Standardized Information for Process/Product Change Notification (PCN)

Not for publication unless permission is granted by LEM			1. PCN basic data	
1.1 Company	 Life Energy Motion		LEM International SA Route du Nant d'Avril 152 1217 Meyrin Switzerland	
1.2 PCN No.	PCN-066_2024_0-OMTM2412301 (UPDATE with date code)			
1.3 Title of PCN	Shield nickel plating process & supplier change			
1.4 Product Category	Electronic module - Current sensor			
1.5 Issue date	2025/09/17			
1.6 PCN revision history (optional)	1.7 Issue date of previous revision (optional)	1.8 Delta to previous revision (optional)

Life Energy Motion	LEM International SA Route du Nant d'Avril 152 1217 Meyrin Switzerland
Changes Description

Shield parts

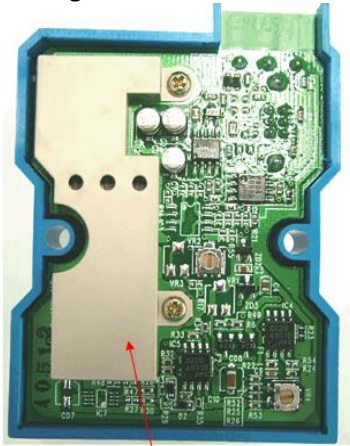
Change 1

Present:
shield parts with Electroless nickel plating on plastic

Next:
shield parts with Evaporated nickel plating on plastic
